Service Bulletin

Subject: Jeep Gladiator Vertical Tire Mount **59060011 AA-AB**

***Kits purchased before June 2024**

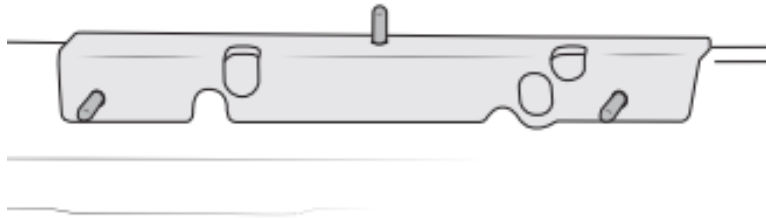
Condition: If your AEV Jeep Gladiator Vertical Tire Mount was purchased before June 2024, or if it includes the bulkhead cross bracket shown below, there is a risk of cracking in the truck bed bulkhead of your vehicle.

AEV's warranty support team is available to send updated bracketry free of charge to address and prevent potential bed damage. Should your truck bed show any signs of cracking, please reach out to our team at 248-926-0256 and follow the prompts for parts or upfit vehicle warranty as applicable. You can also reach out via email: warranty@aev-conversions.com.
